**ANP-10315 —U.S. EPR
Surveillance Testing and
TELEPERM XS
Self-Monitoring Technical
Report Markups**

U.S. EPR ~~Protection System~~
Surveillance Testing and TELEPERM XS
Self-Monitoring

ANP-10315NP
Revision ~~2~~**4**

RAI 505
Question 07.01-44

Figure 2-1—U.S. EPR PS Testing Philosophy Overview

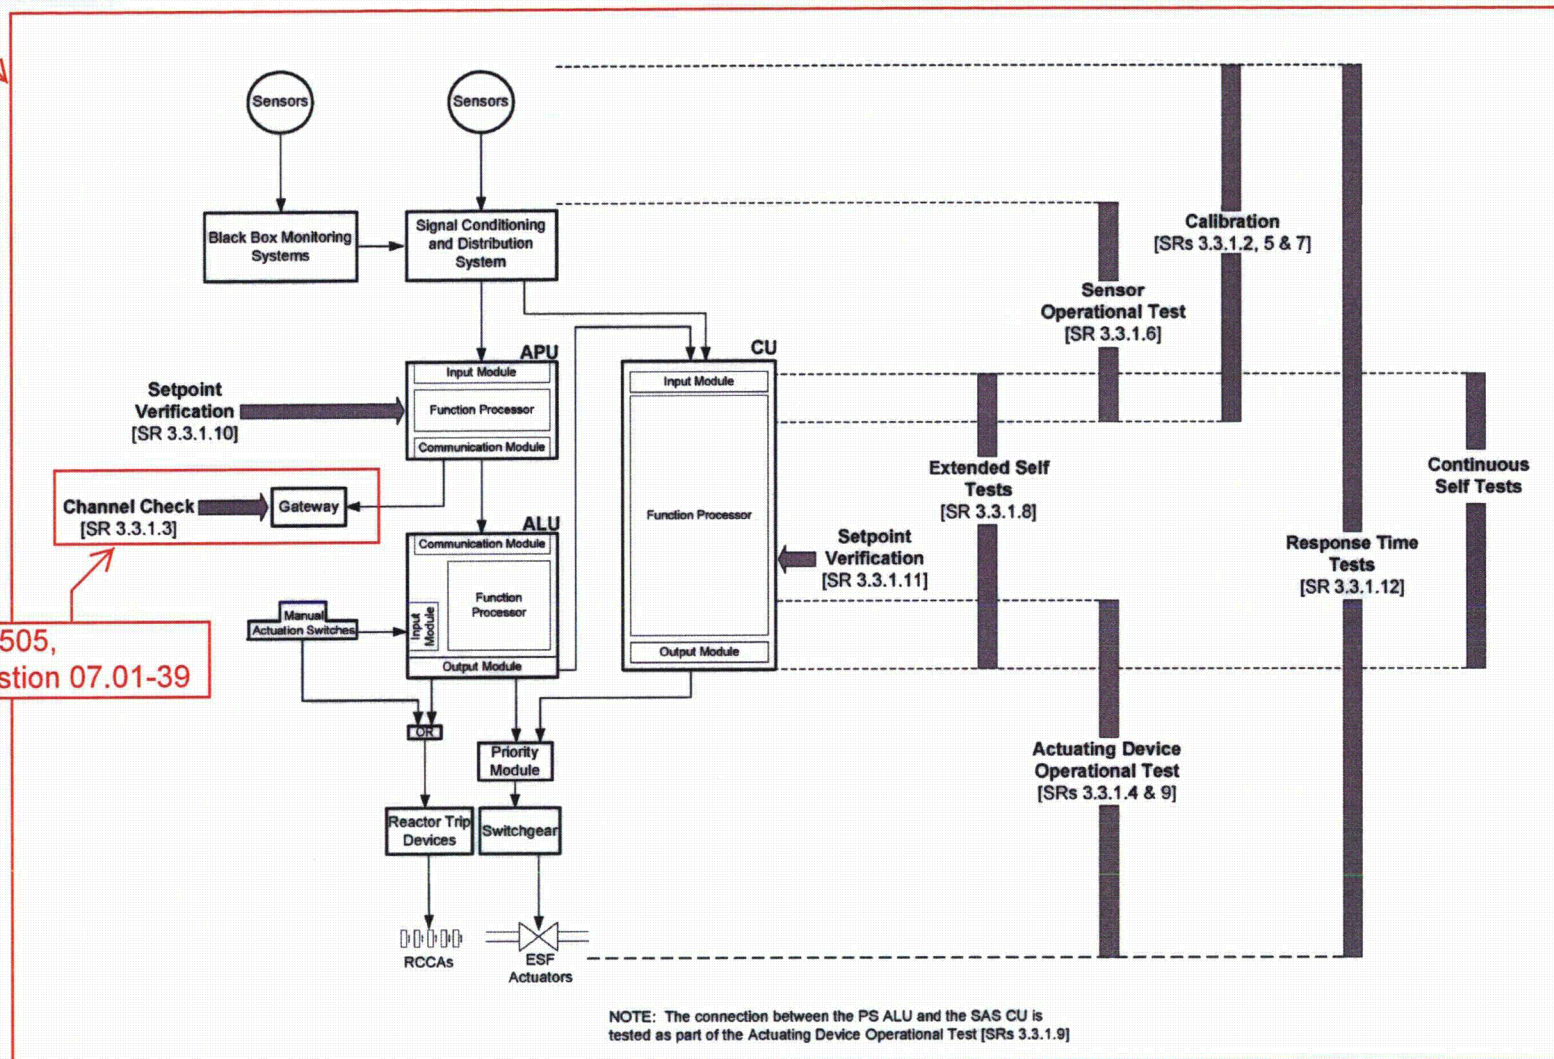
Figure 2-1 represents the U.S. EPR safety-related I&C systemsPS overlap testing philosophy and shows which portions of the safety-related I&C systemsPS are periodically tested through technical specification surveillance requirements, and which parts are continuously tested through self-monitoring features.

This section addresses each of the various overlapping tests shown in Figure 2-1, identifies the system equipment covered by each test, and provides information about how the testing is generally performed. Specific testing strategies and procedures will be developed by each COL applicant referencing the U.S. EPR standard design. A COL applicant may choose to perform a surveillance testing alternative from those described in this section. Descriptions of how testing is performed in this section are

Figure A-1—DAS Testing

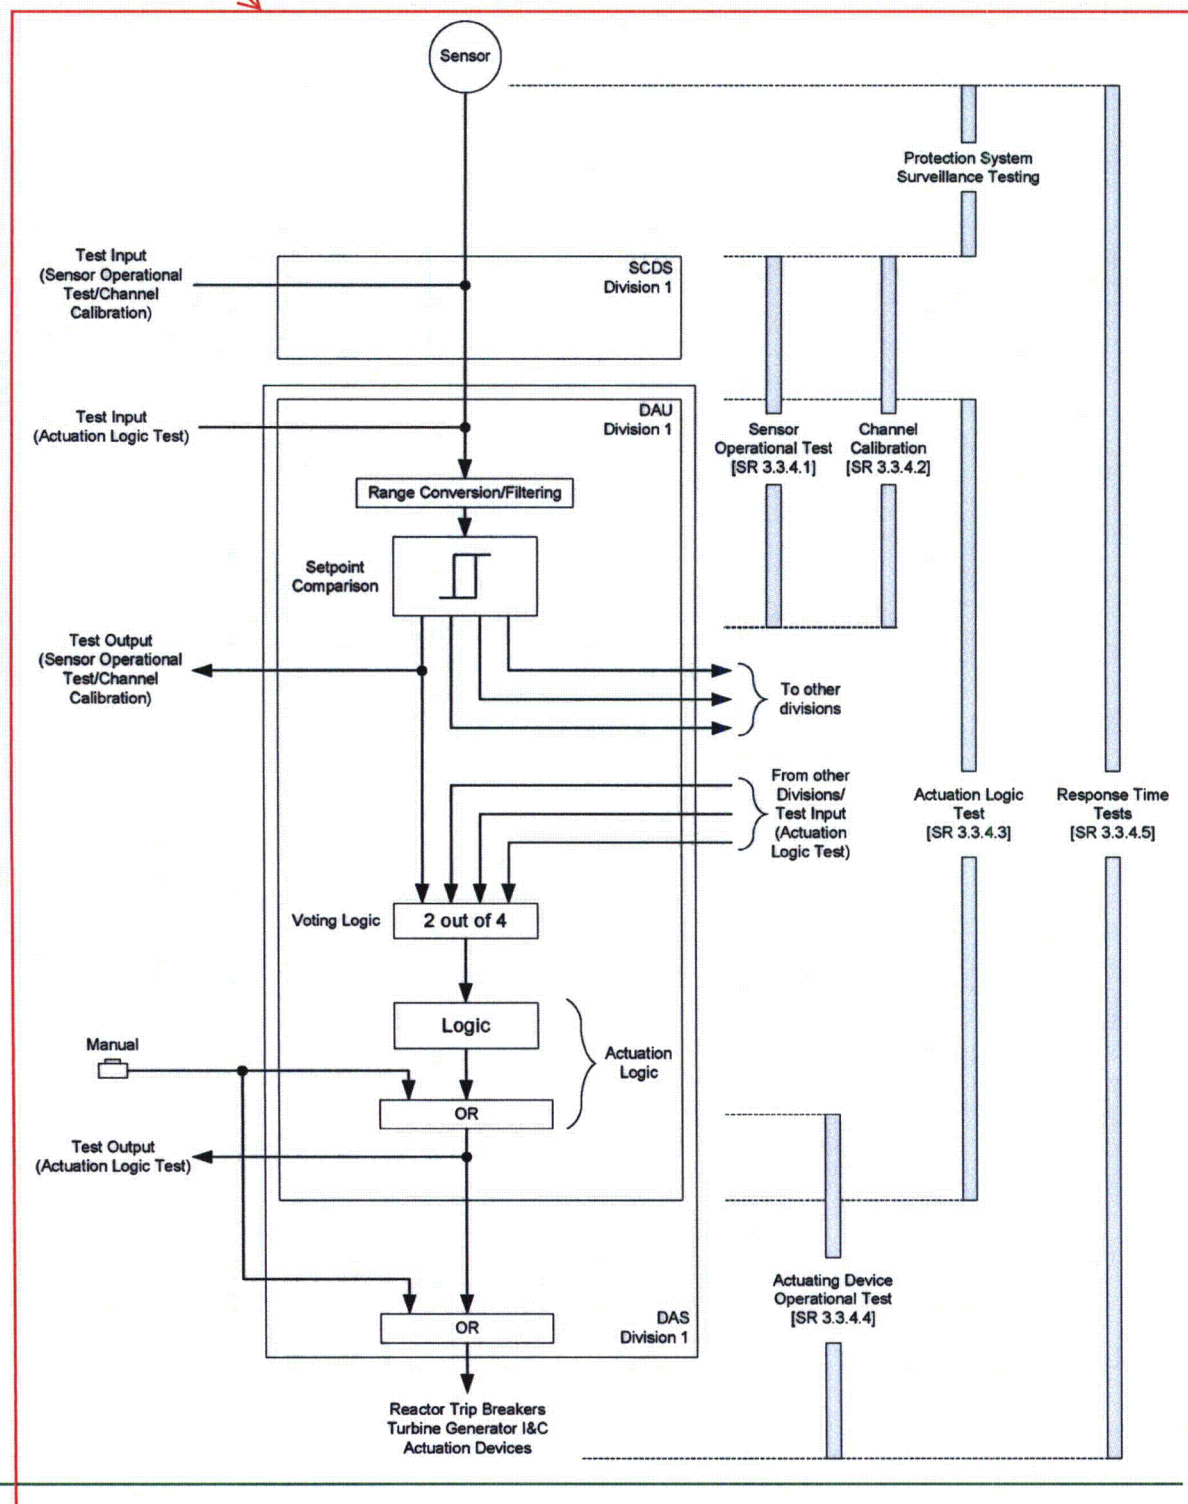
Figure A-1 represents the U.S. EPR DAS overlapping test philosophy, and shows which portions of the DAS are periodically tested to meet the surveillance requirements. This figure also shows the general concept for each test. Sensors shared by the protection system (PS) and DAS are tested as part of the PS. These sensors are not tested separately as part of the DAS periodic testing.
